# ZAYO'S PRINEVILLE TO RENO PROJECT

## CPUC MINOR PROJECT REFINEMENT FORM

<b>Date Requested:</b> 15 Oct 2024	<b>Report No.:</b> 9
<b>Date Approved:</b> 11/6/24	<b>Approval Agency:</b> Caltrans, in addition to CPUC
<b>Property Owner(s):</b> Caltrans (State Route 395 ROW)	<b>Location/Milepost:</b> PM L-98.7 to L-99.5 (S to N)
<b>Land Use/Vegetative Cover:</b> Ruderal (maintained highway shoulder near edge of pavement)	<b>Sensitive Resources:</b> No sensitive resources present. (See project webmap.)

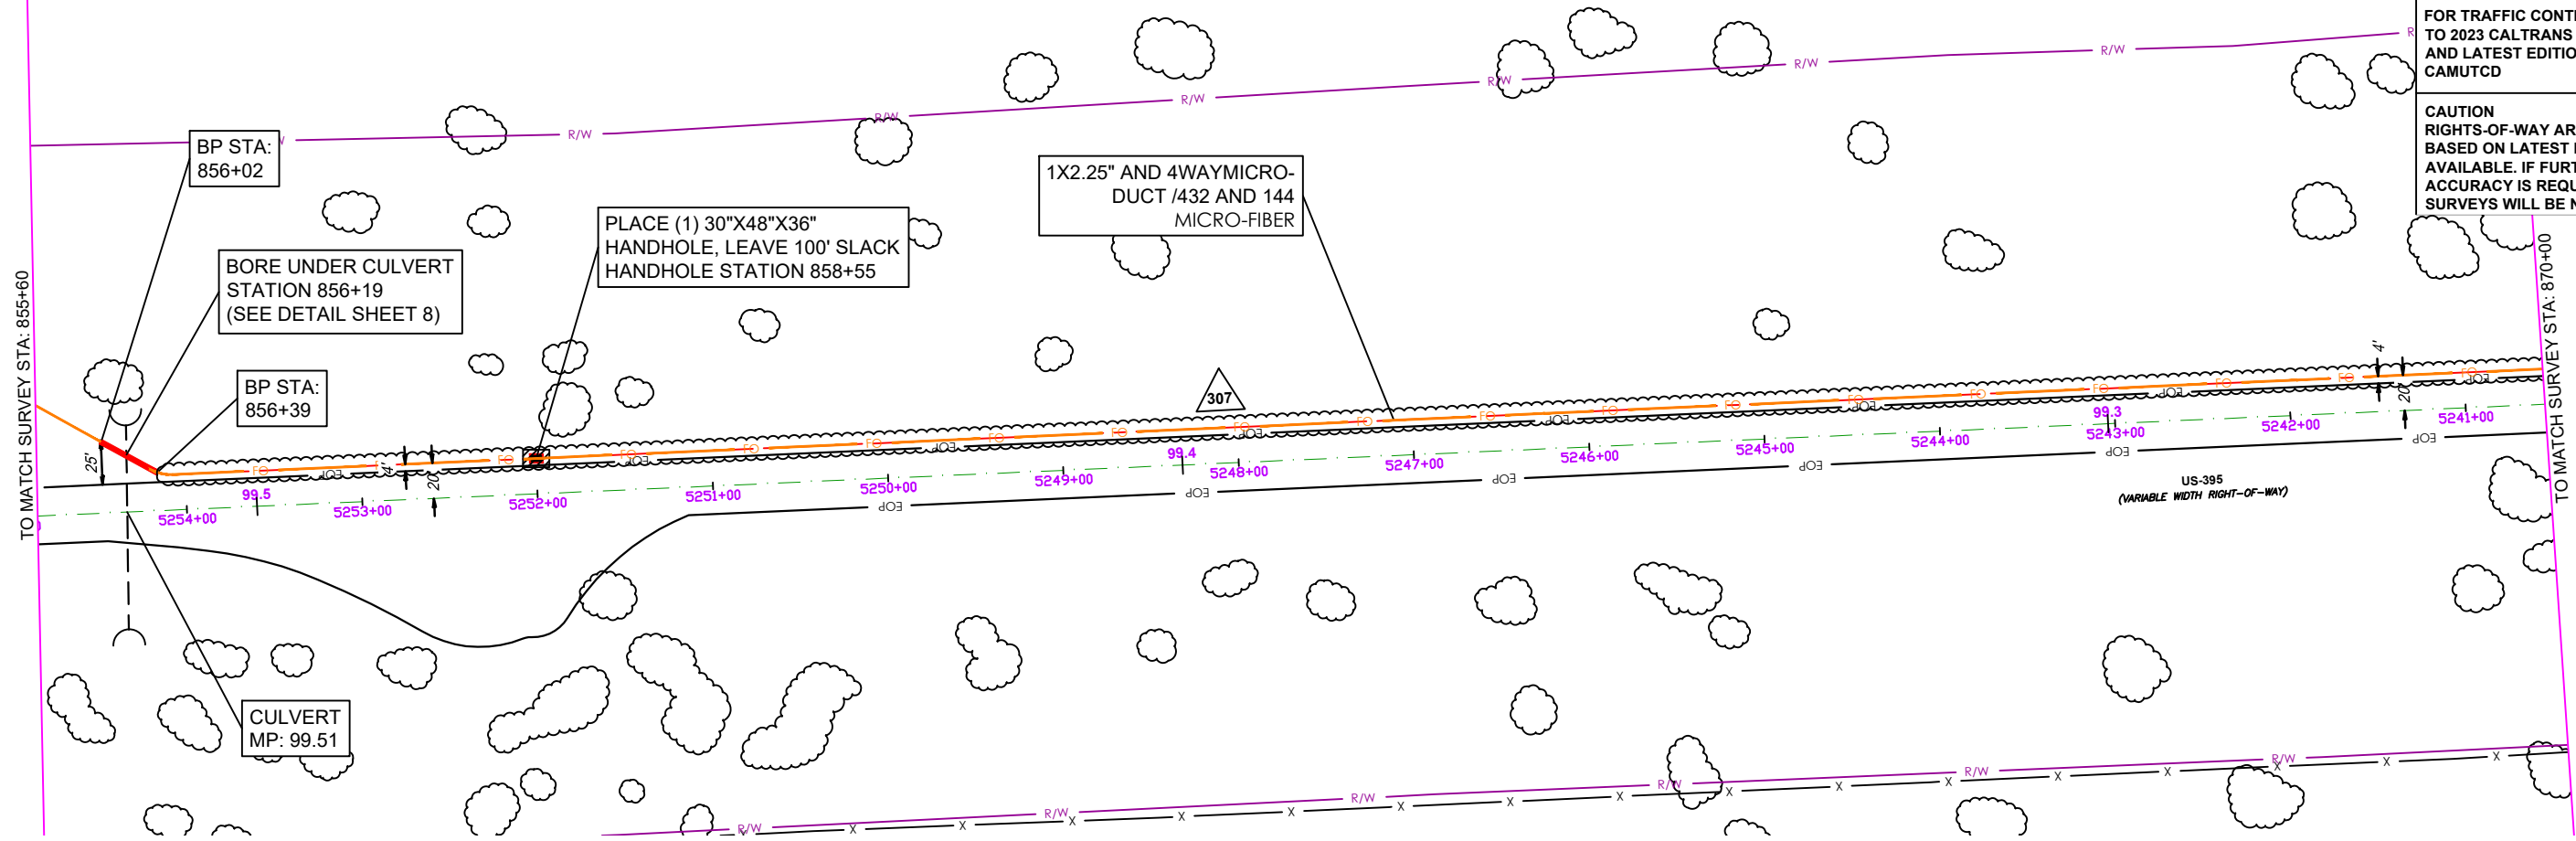
The proposed change is a shift of the fiber optic running line from previously submitted engineering drawings. The change entails shifting the running line towards the roadway to avoid rocky slopes and tree driplines.

<b><u>Conditions of Approval or Reason for Denial:</u></b>	
The applicable Conditions of Approval from the Project Conditions, Monitoring, Compliance, and Reporting Program apply to this request.	
Evidence of Caltrans approval to be supplied to CPUC prior to construction in this area.	
Prepared by: ECORP Consulting	Date: 11/6/24

**VIEWPORT - 66**

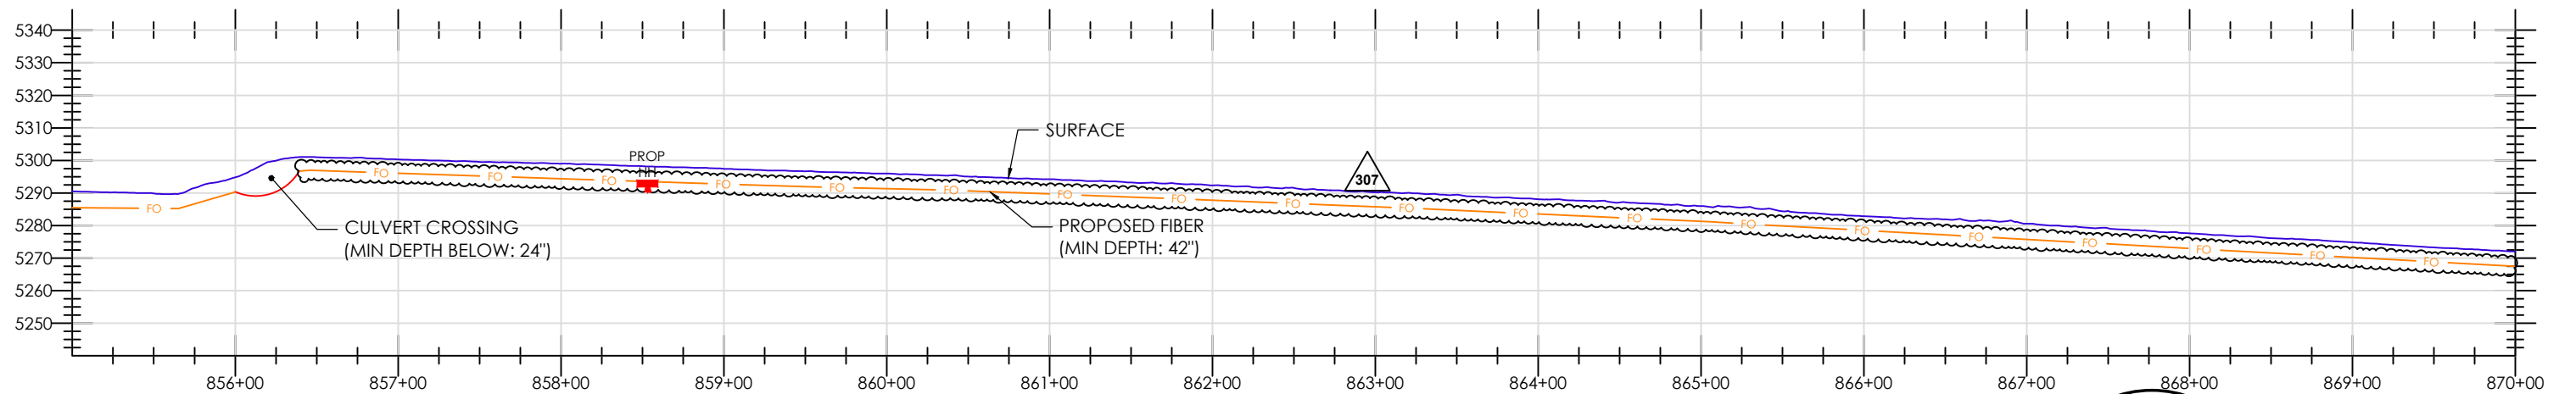
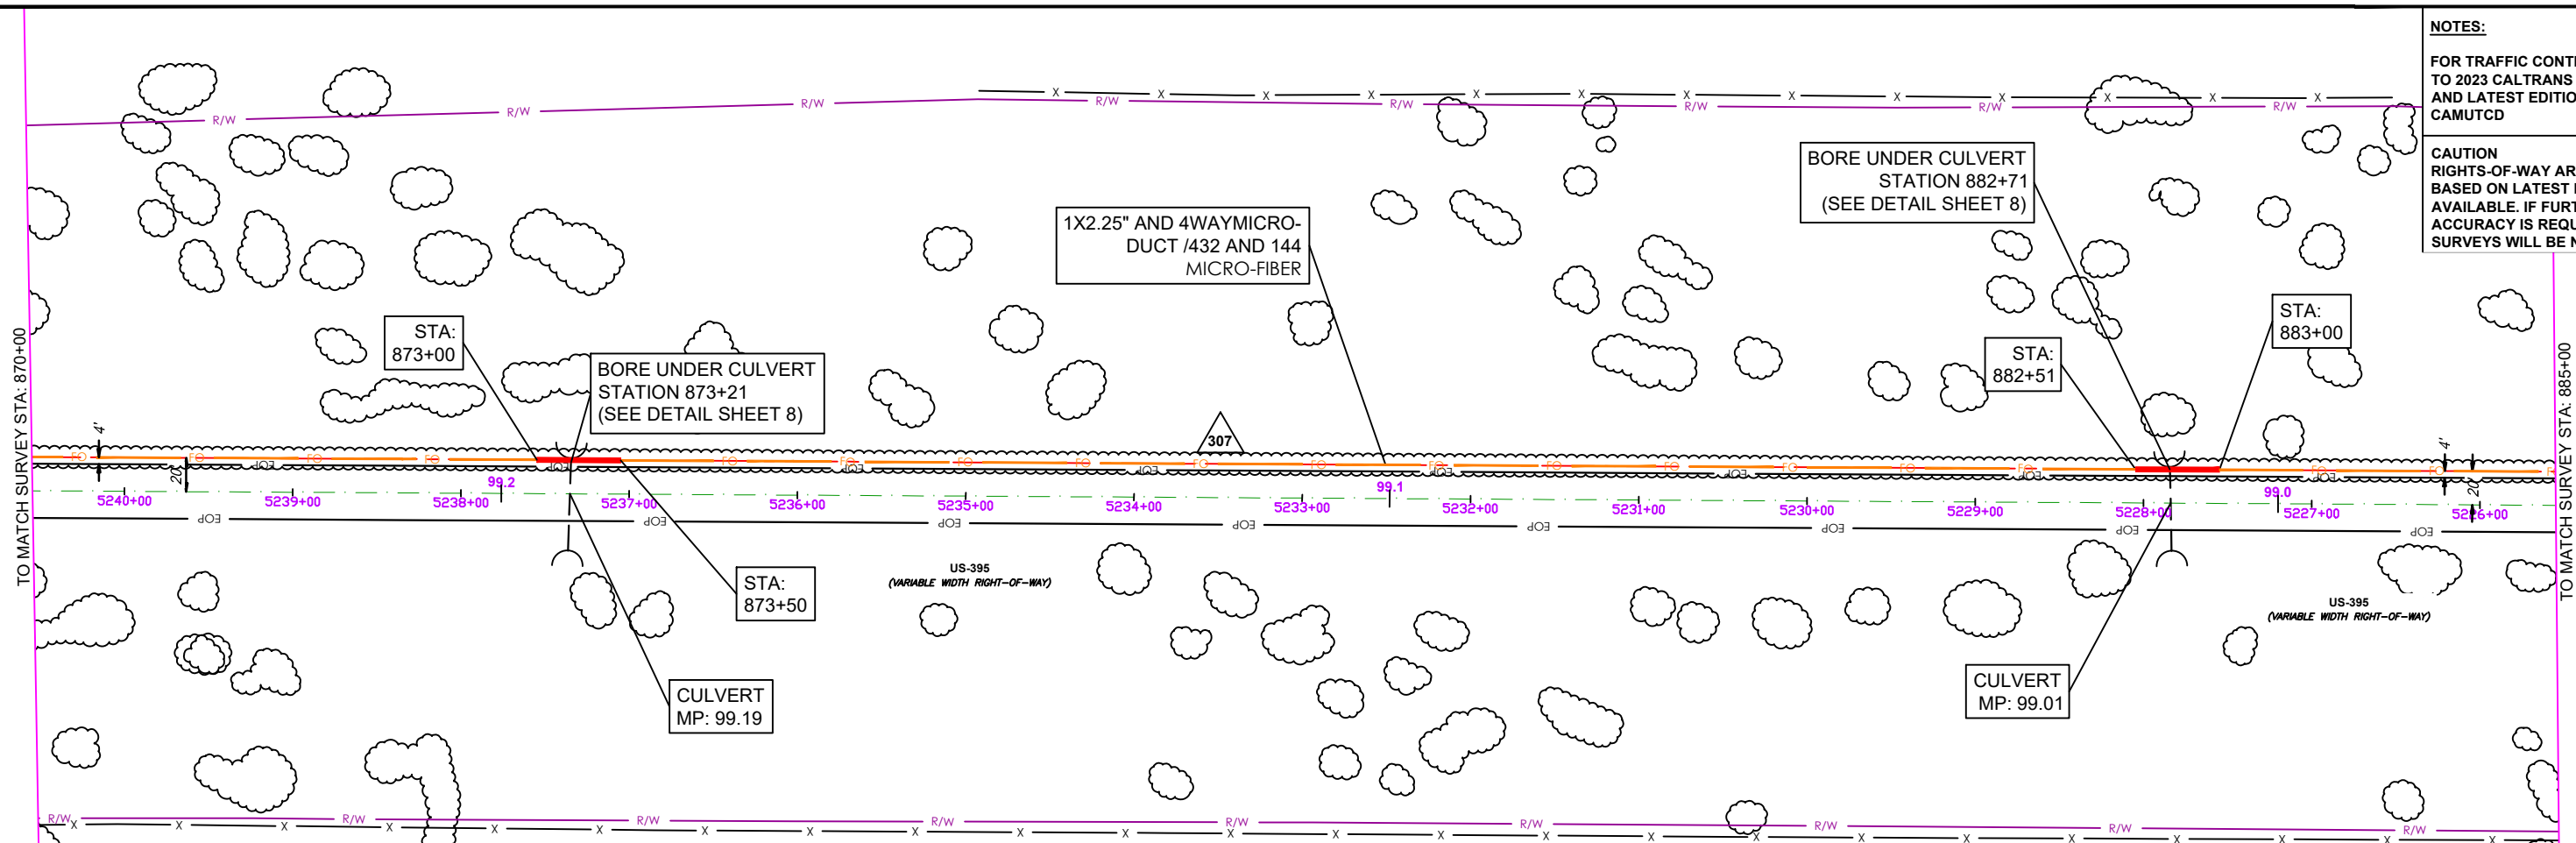
RFI NO. 0307  
 SHIFT R/L TO 4 FEET FROM EOP  
 STA 856+34 TO STA 899+00

**VIEWPORT - 67**

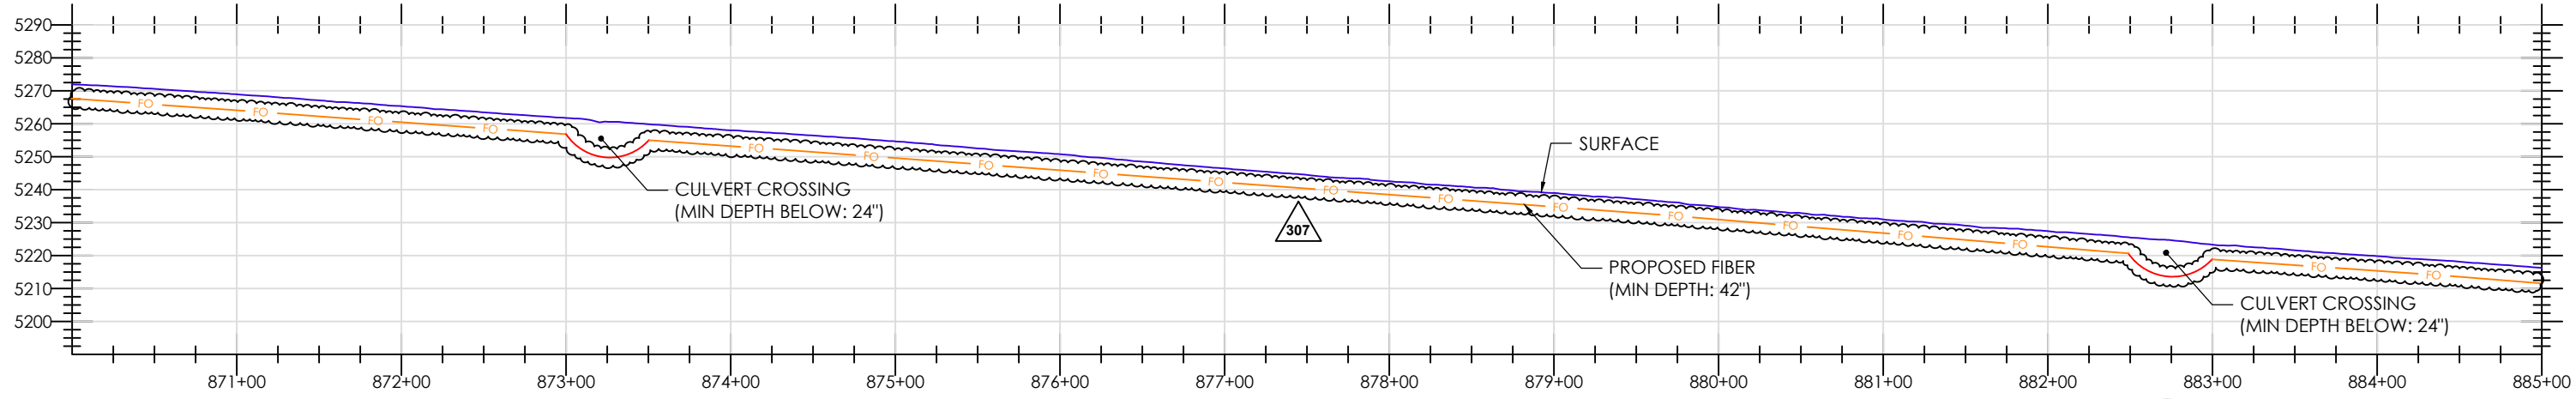
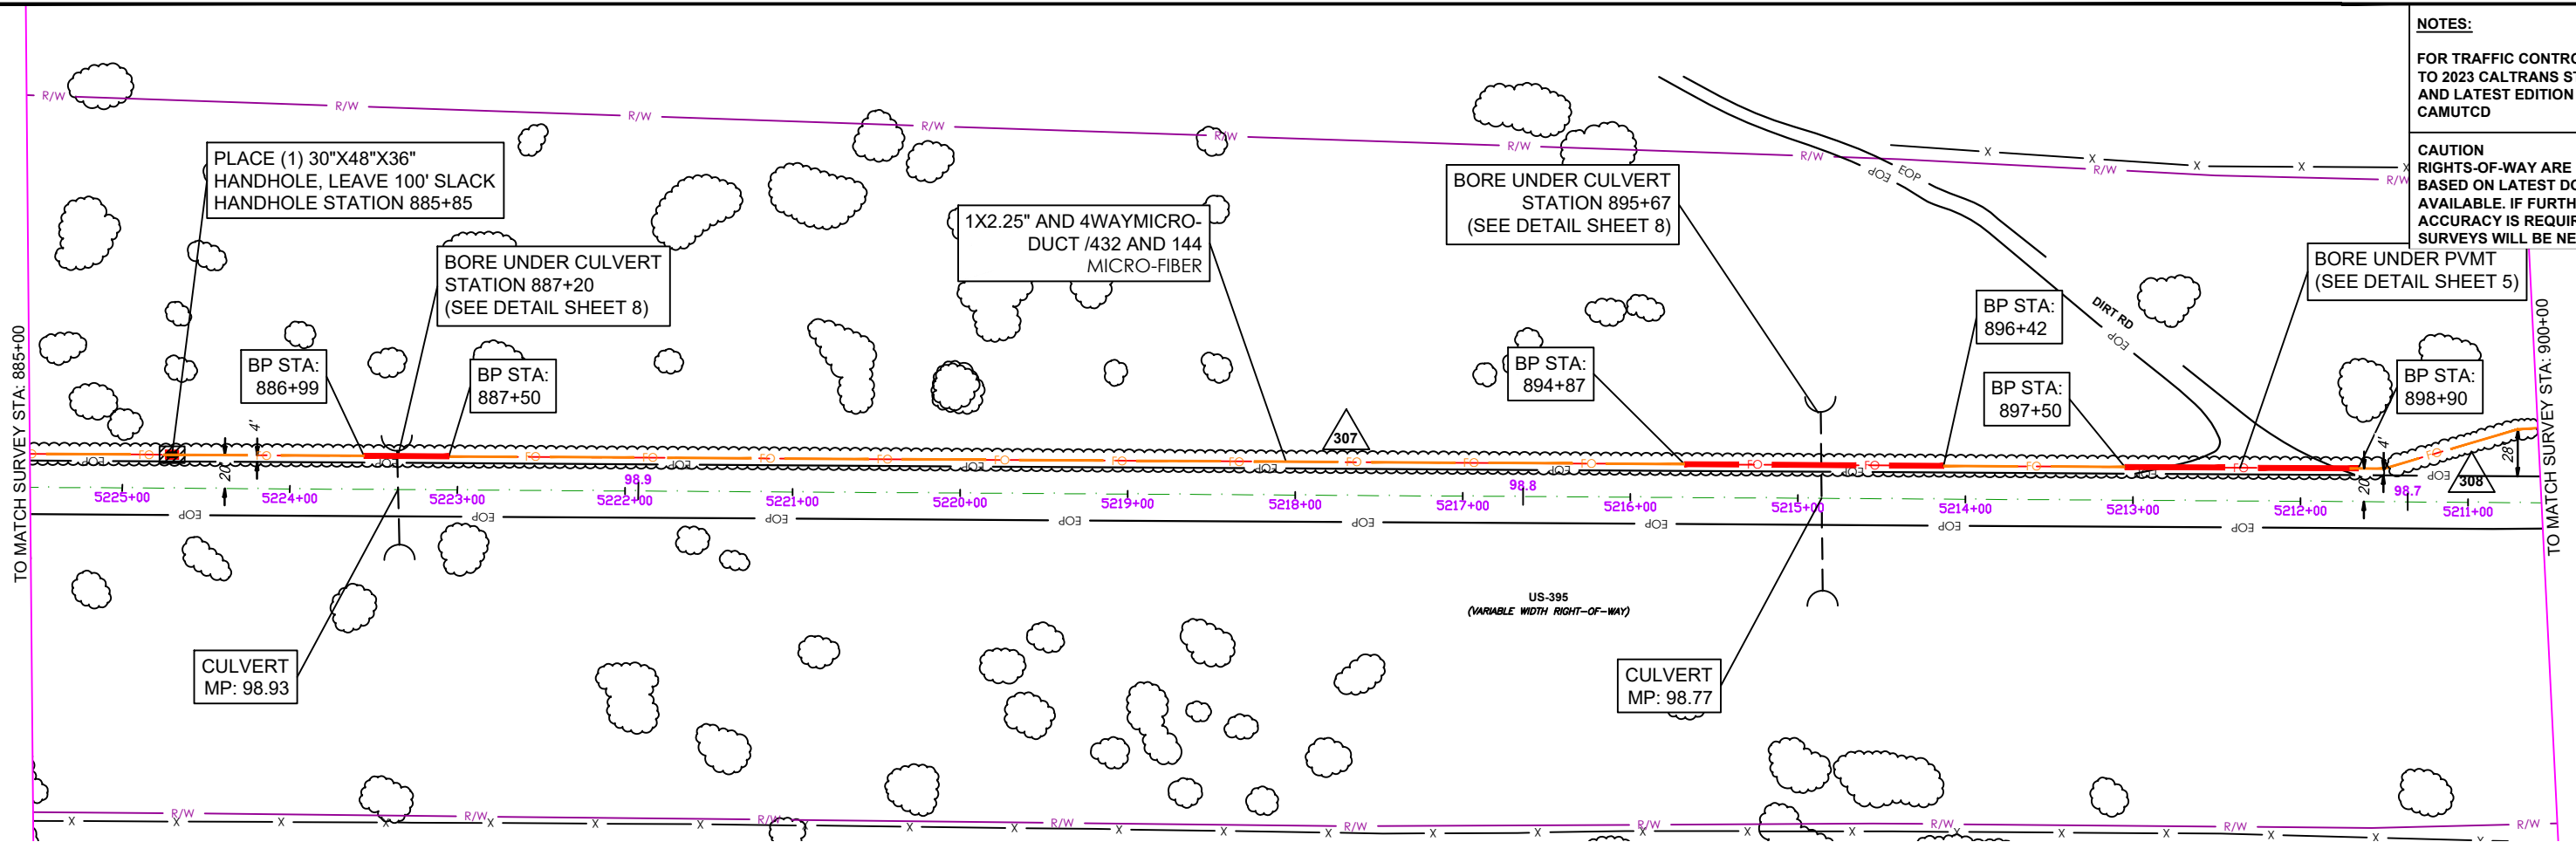
RFI NO. 0307 SHIFT R/L TO 4 FEET FROM EOP STA 856+34 TO STA 899+00	10/04/2024
--	------------

**VIEWPORT - 68**

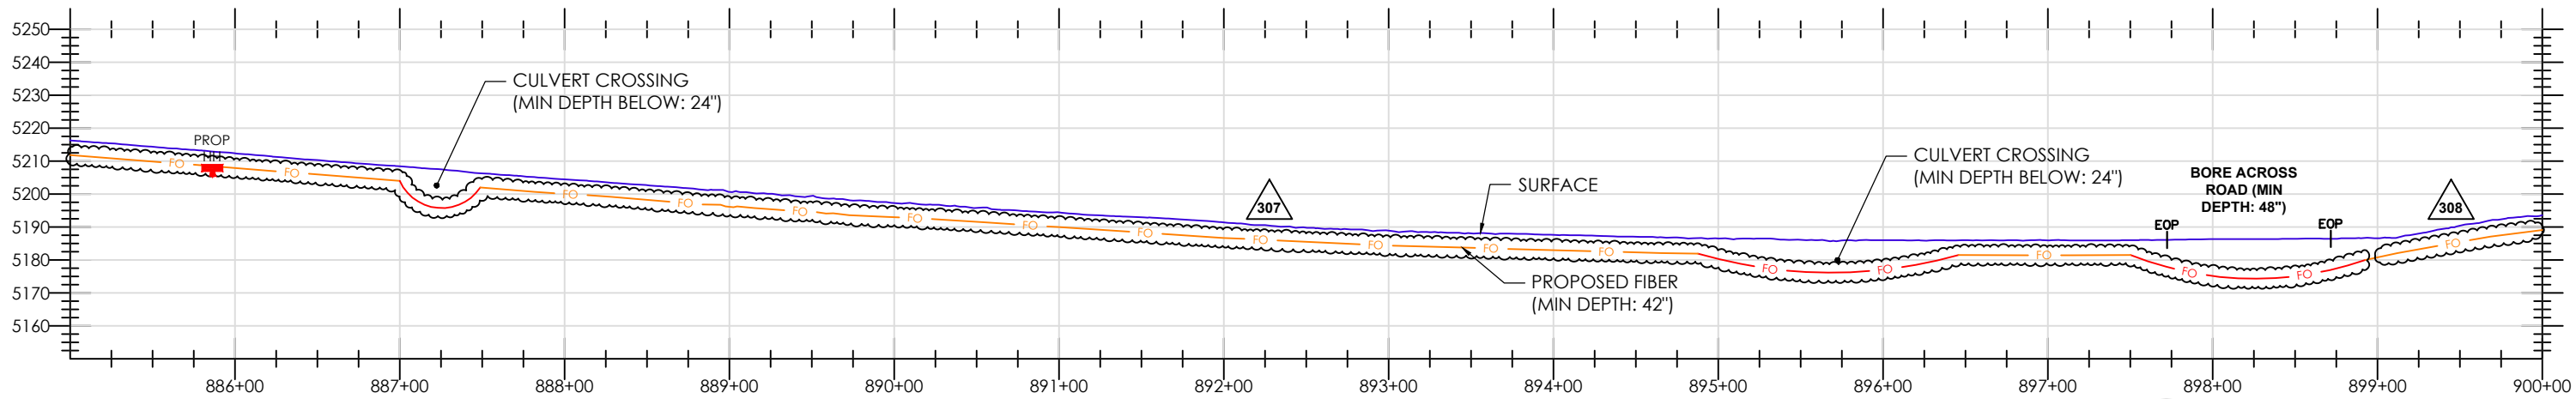
RFI NO. 0307 SHIFT R/L TO 4 FEET FROM EOP STA 856+34 TO STA 899+00	10/04/2024
RFI NO. 0308 ANGLE R/L FROM 4 FT TO 28 FT STA 899+00 TO 900+00	10/04/2024
